PENTODEBLASTER

PROJECT: PENTODEBLASTER		
DESIGN TITLE: PROTOTYPING OPTIMIZATIONS		
AUTHOR: Laurent	DRAWING NUMBER P025-V2D-01	REV: V2E
DATE: 2016-01-26	SIZE: A4	SHEET: 1 of 1

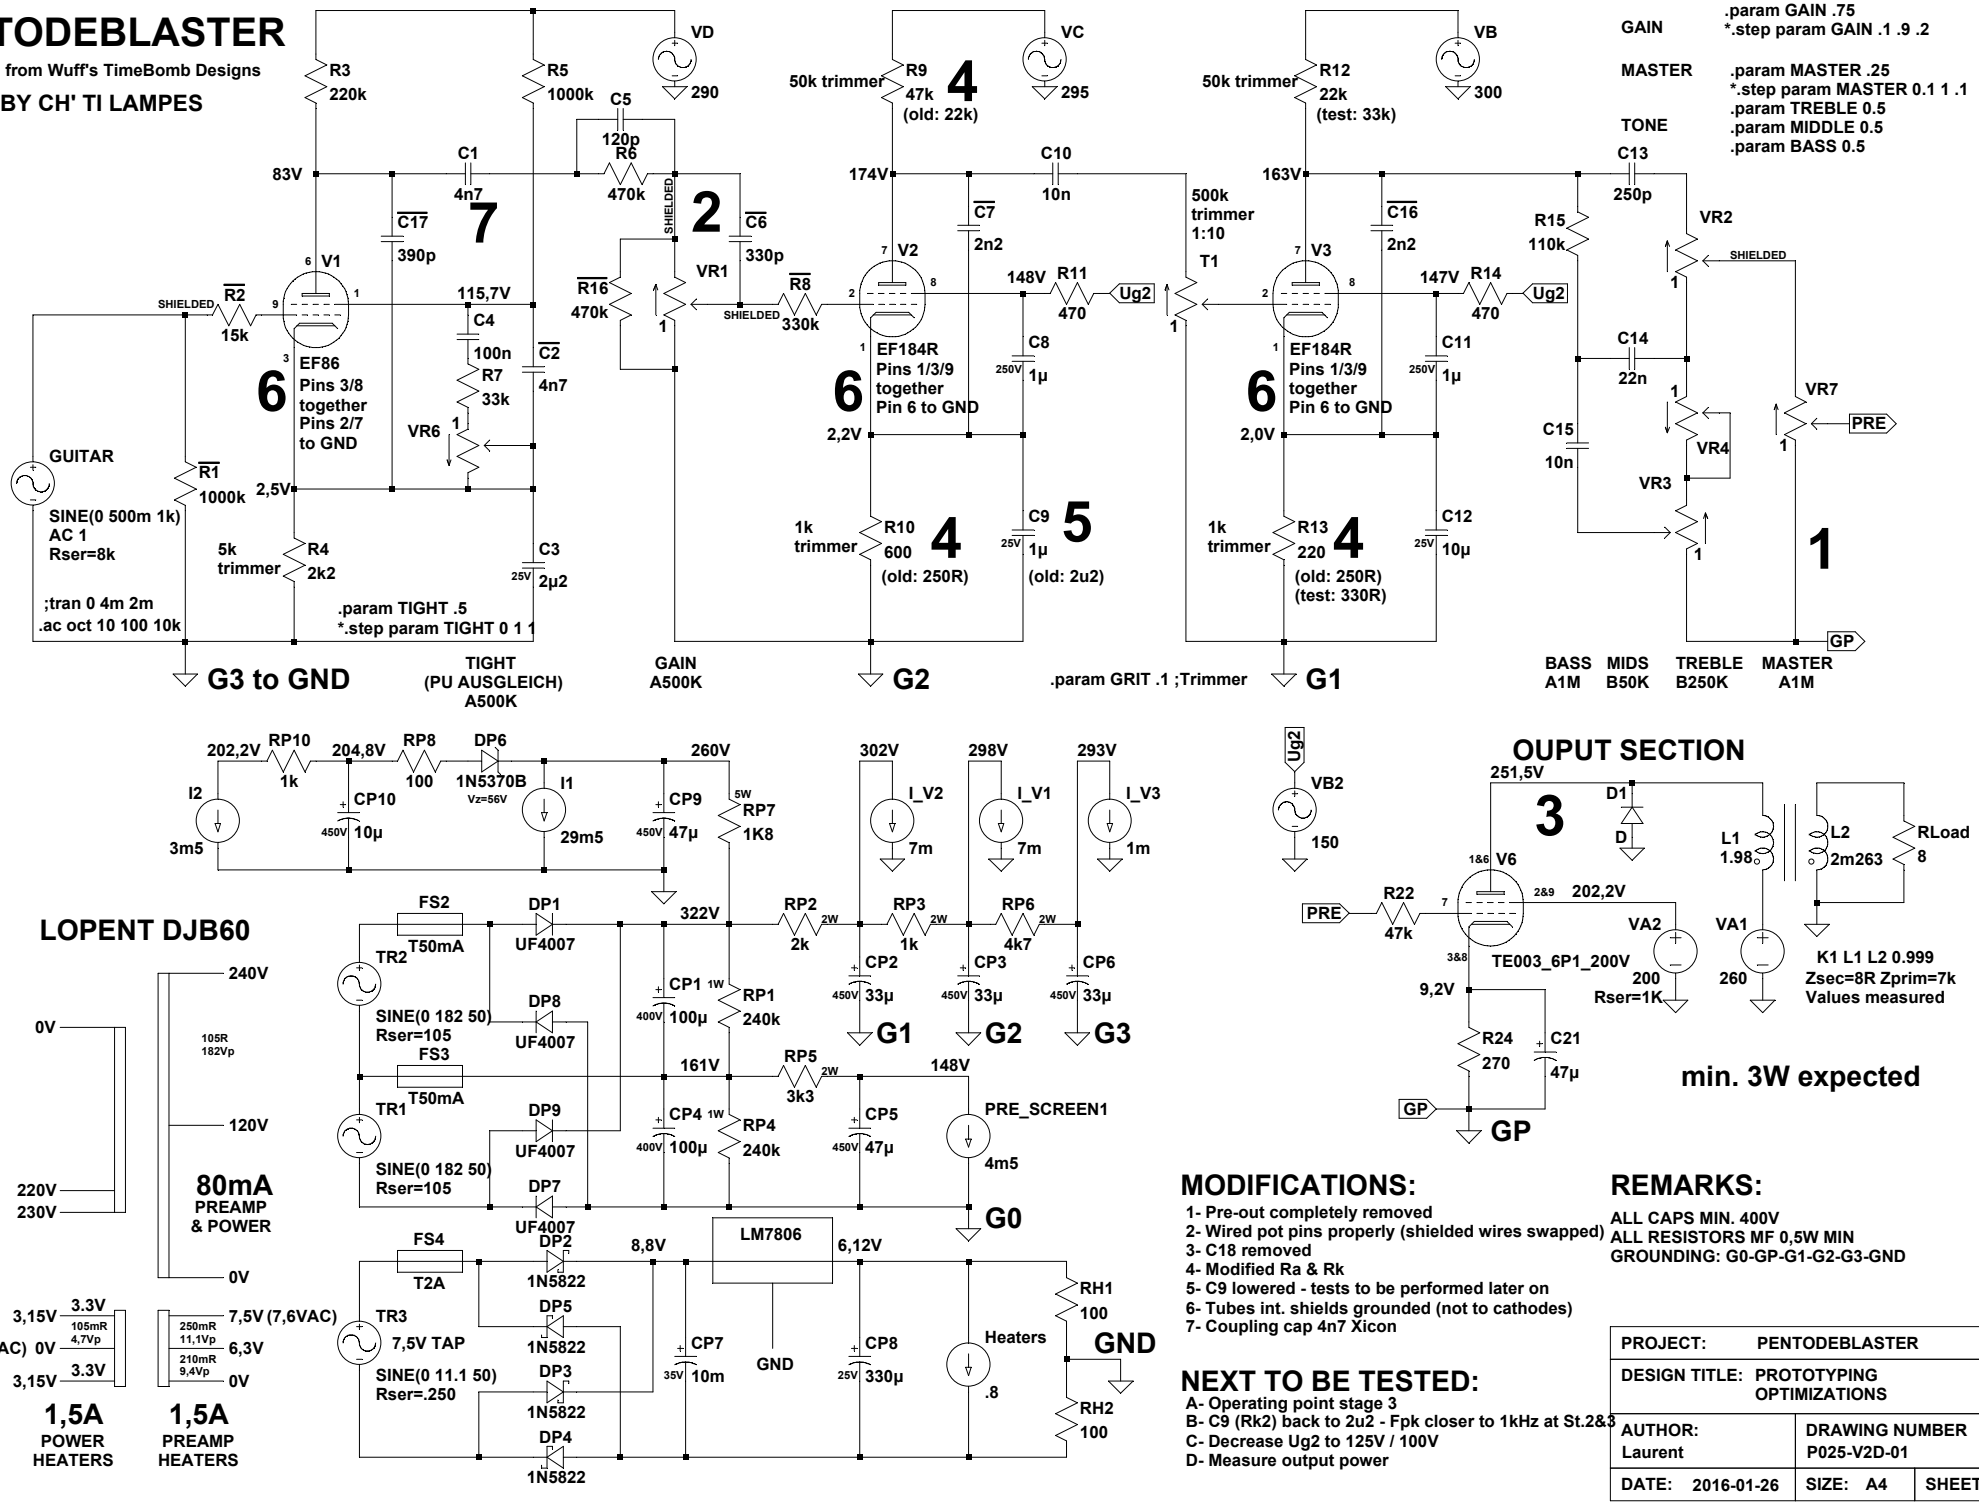
1- Pre-out completely removed
2- Wired pot pins properly (shielded wires swapped)
3- C18 removed
4- Modified Ra & Rk
5- C9 lowered - tests to be performed later on
6- Tubes int. shields grounded (not to cathodes)
7- Coupling cap 4n7 Xicon

A- Operating point stage 3
B- C9 (Rk2) back to 2u2 - Fpk closer to 1kHz at St.2&3
C- Decrease Ug2 to 125V / 100V
D- Measure output power
